2.2 Control and Instrument Systems

The information in this section of the reference ABWR DCD, including all subsections, tables, and figures, is incorporated by reference with the following departures.

Figure 2.2.1 Rod Control and Information System Control Interface Diagram

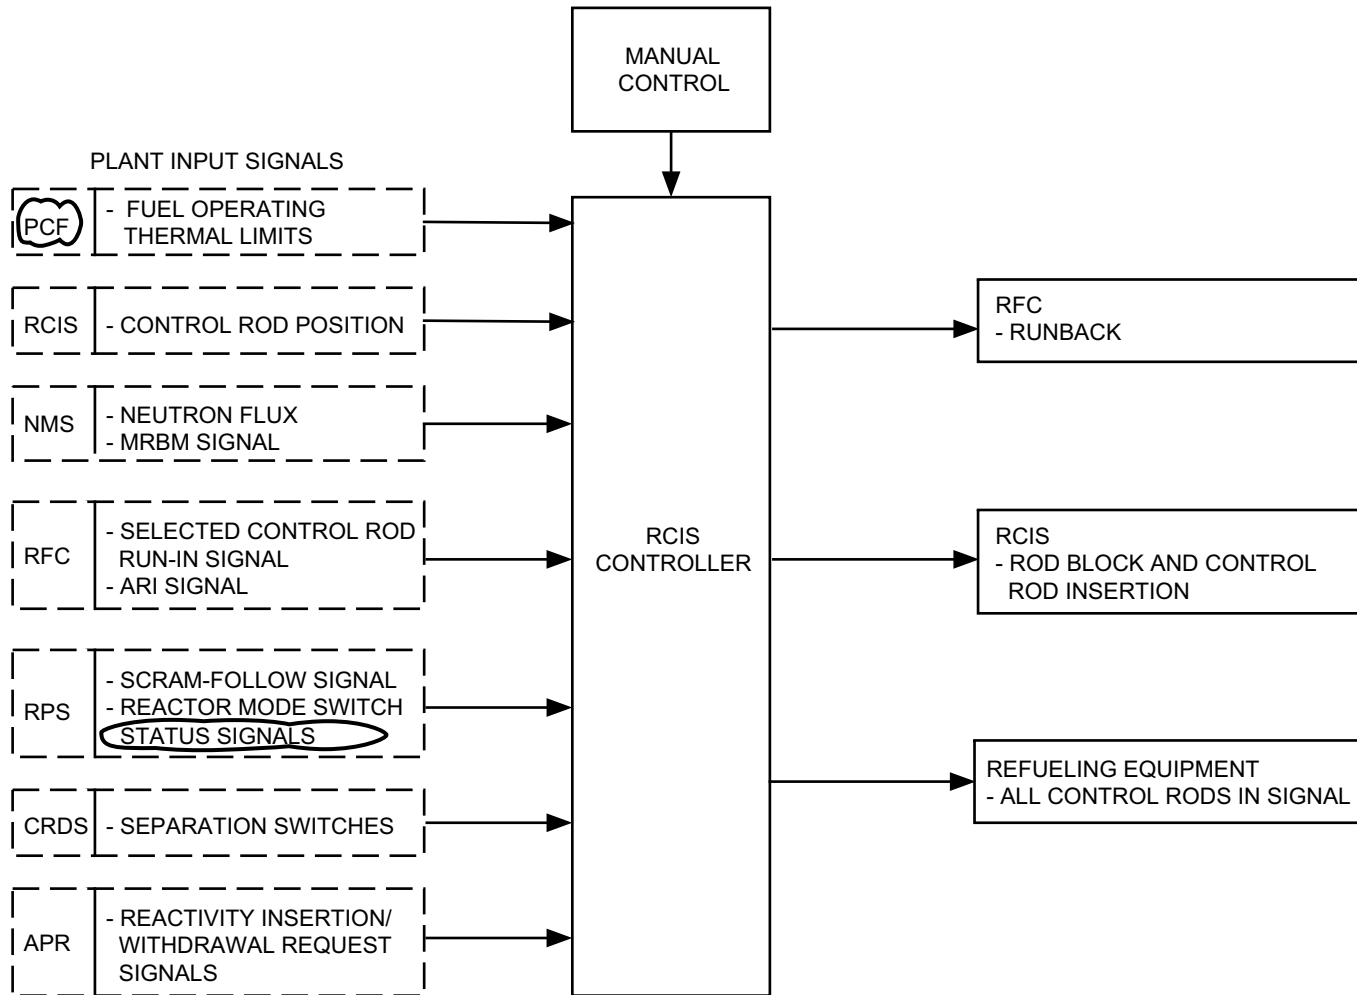
STD DEP T1 2.2-1 (Figure 2.2.1—RPS, Table 2.2-1—Item 8)

STD DEP T1 3.4-1 (Figure 2.2.1—PCF)

NOTE:
1. INTERCONNECTIONS MAY BE FIBER-OPTIC OR METALLIC.

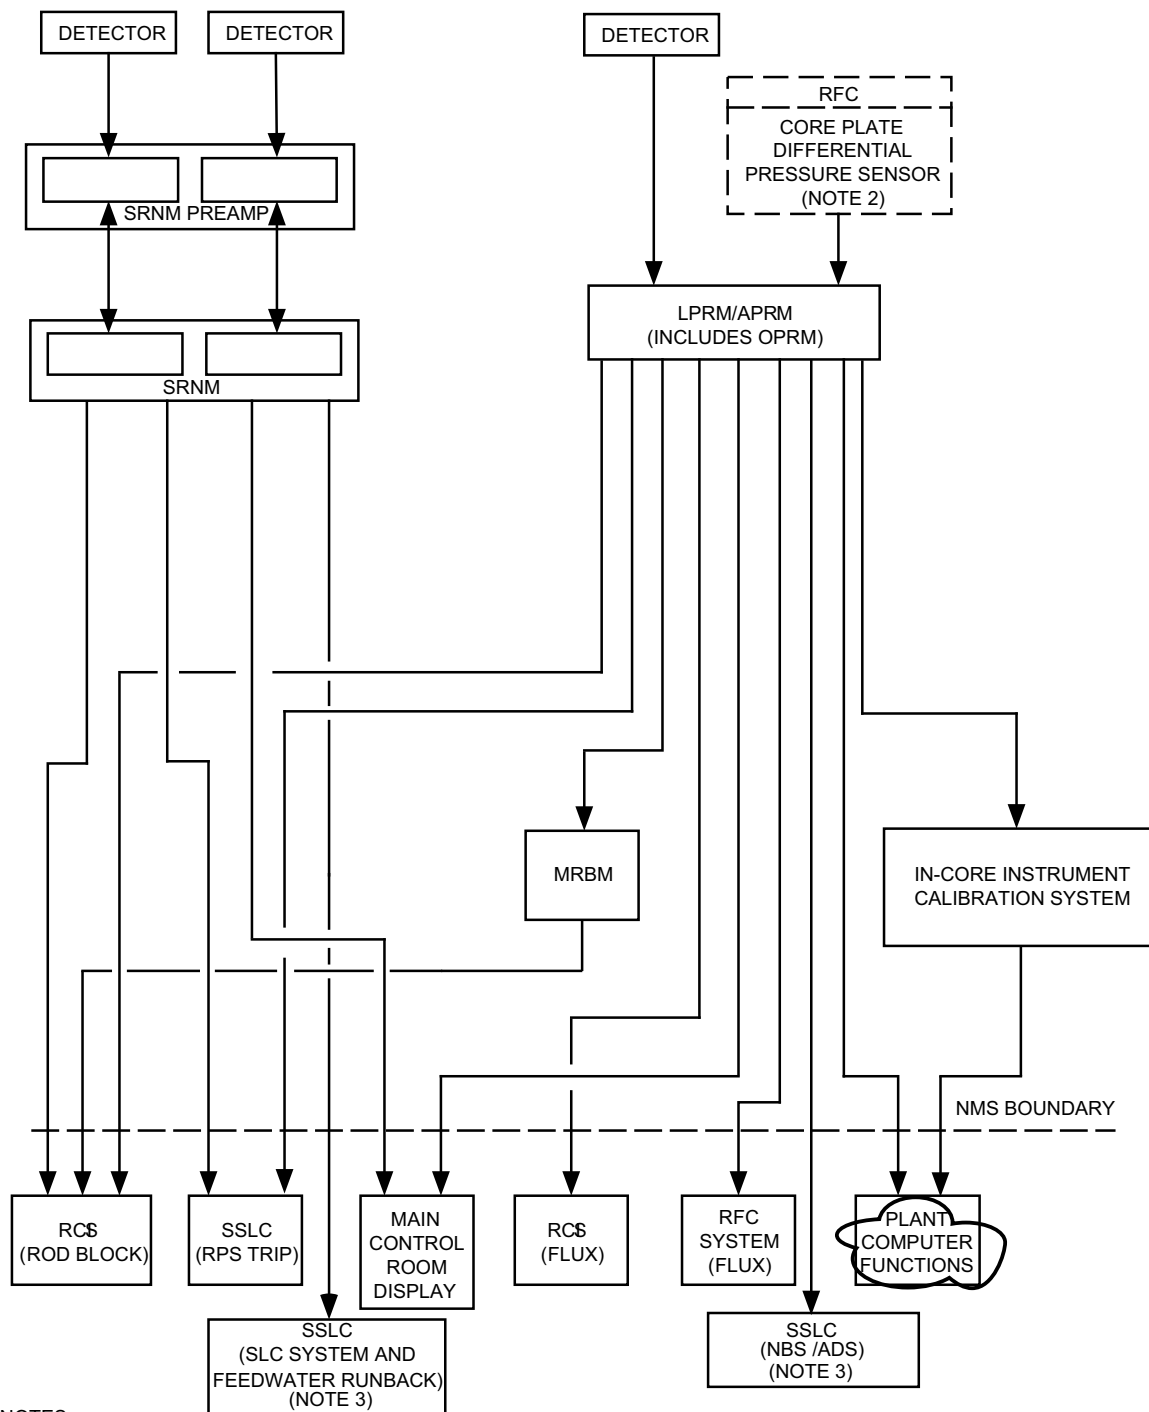
The FDWC digital controllers determine narrow range level signal using three reactor level measurement inputs from the NBS. ~~Sensor signals are transmitted to the FDWC digital controllers by the Non-Essential Multiplexing System (NEMS).~~

The steam flow in each of four main steamlines is sensed at the RPV nozzle venturis. ~~Sensor signals are transmitted to the FDWC System digital controllers by the NEMS.~~ These measurements are processed in the digital controllers to calculate the total steam flow out of the vessel.

Feedwater flow is sensed at a flow element in each of the two feedwater lines. ~~Sensor signals are transmitted to the FDWC digital controllers by the NEMS.~~ These measurements are processed in the digital controllers to calculate the total feedwater flow into the vessel.

The total feedwater flow is displayed on the main control panel. The FDWC System operating mode is selectable from the main control room. ~~The FDWC System microprocessors are located in the Control Building.~~

Figure 2.2.7a Reactor Protection System Control Interface Diagram

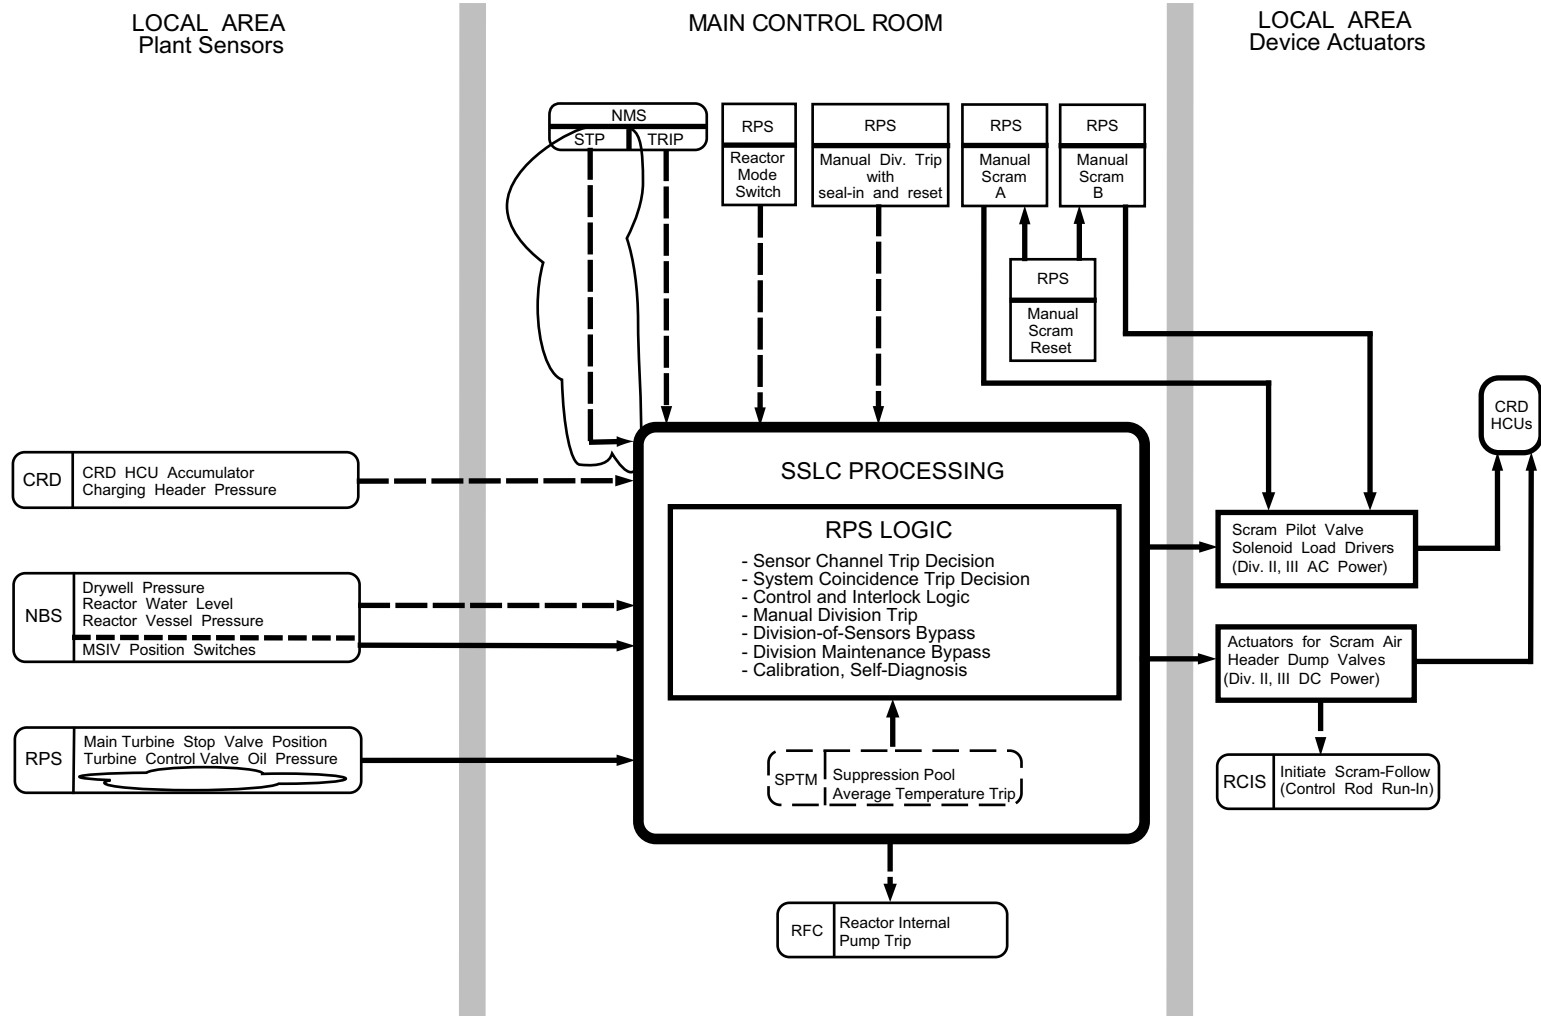
STD DEP T1 2.2-1 (Figure 2.2.7a, Table 2.2.7)

As shown in Figure 2.2.7a, the RPS interfaces with the Neutron Monitoring System (NMS), Nuclear Boiler System (NBS), Control Rod Drive (CRD) System, Rod Control and Information System (RCIS), Recirculation Flow Control (RFC) System, and the Suppression Pool Temperature Monitoring System (SPTM), ~~and the Essential Multiplexing System (EMS)~~. Figure 2.2.7a also depicts the primary implementation of RPS logic within the Safety System Logic and Control (SSLG).

As shown on Figure 2.2.7a, the RPS has manual divisional trip switches, reactor mode switch, manual scram switches, and scram reset switches for manual controls. Divisional trip displays, and scram solenoids electrical power status lights are also provided. These RPS controls and displays are provided in the main control room. Fail safe RPS sensors are turbine control valve oil pressure ~~switches, sensors and turbine stop valve position switches, and turbine first stage pressure sensors.~~ switches, sensors and turbine stop valve position switches, and turbine first stage pressure sensors. ~~These sensors are located in the Turbine Building.~~

Figure 2.2.7b Reactor Protection System

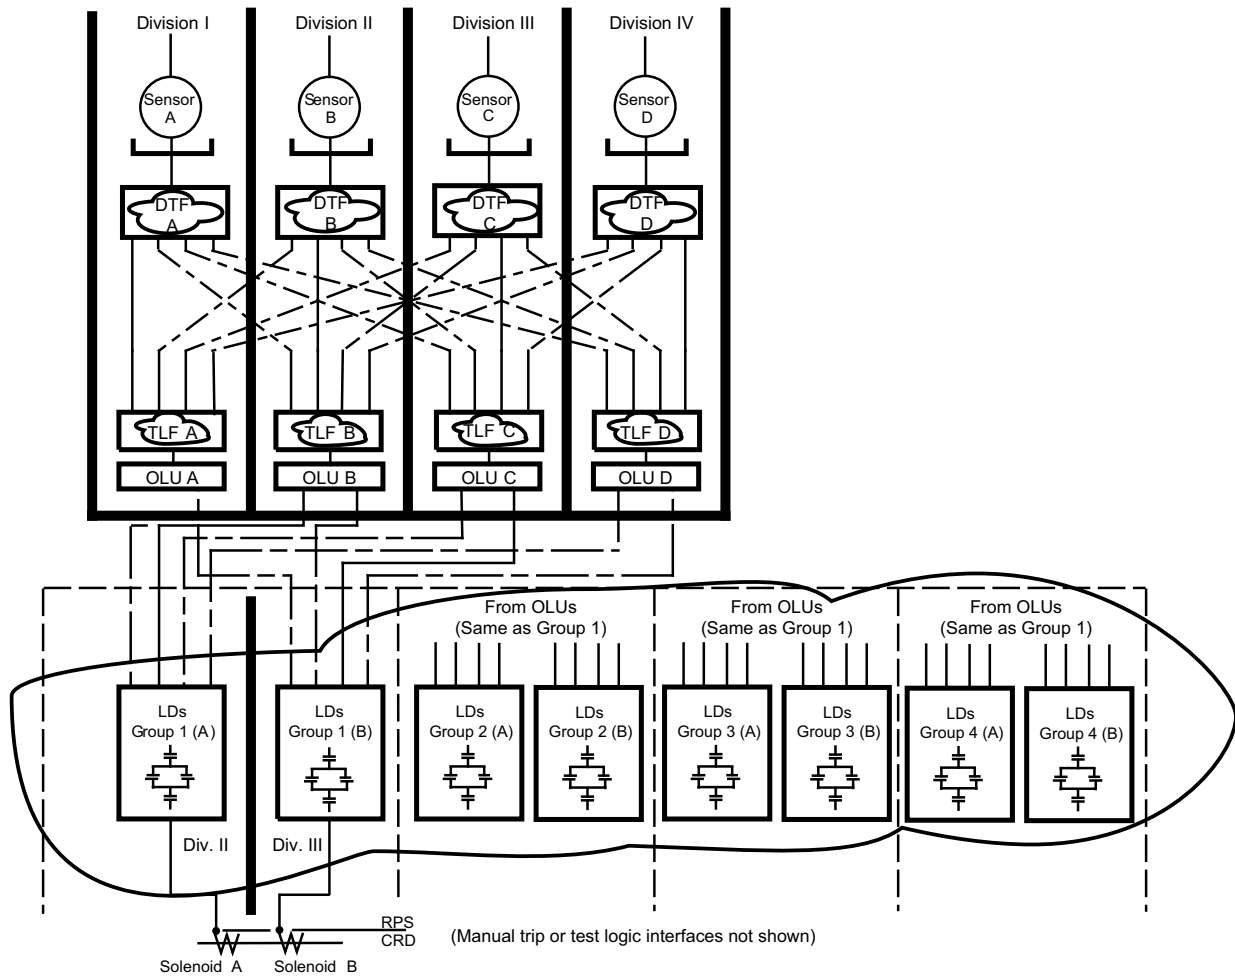
STD DEP T1 3.4-1 (Figure 2.2.7b)

The RPS has four divisions. Figure 2.2.7b shows the RPS divisional aspects and the signal flow paths from sensors to scram pilot valve solenoids. Functions ~~Equipment~~ within an RPS division ~~consists of~~ include sensors (transducers or switches), ~~multiplexers~~, data communication, digital trip modules functions (DTM DTF), trip logic ~~unit function (TLU TLF)~~, output logic unit (OLU), and load drivers (LD). The LDs are only in Divisions II and III. The (DTF) and (TLF) are performed in digital control processors. The data communication functions are described in Section 2.7.5.

The RPS consists of logic and circuitry for initiation of both automatic and manual scrams. The automatic scram function is ~~comprised of~~ accomplished redundantly in four independent divisions of sensor ~~instrument channels, hardware/software based logic and logic processing~~, and two independent divisions of actuating devices. Automatic scram is initiated whenever a scram condition is detected by two or more automatic divisions of RPS logic. ~~For automatic scram, the sensor input signals to the RPS originate either from the RPS's own sensors or other systems' sensors.~~ For determination of the existence of an automatic scram condition, within each ~~automatic scram channel~~ division of the RPS, the DTM DTF of a given RPS channel division compares the monitored process variable with the a stored setpoint stored in its memory and issues a trip signal if the monitored process variable exceeds the setpoint. The DTM DTF then sends the trip signal to the TLU TLF of its own channel division and the TLU TLFs of the other three channels divisions of RPS, where two out of four voting is performed (see Figure 2.2.7b). The TLF in each division performs an independent two-out-of-four vote on each RPS DTF input.
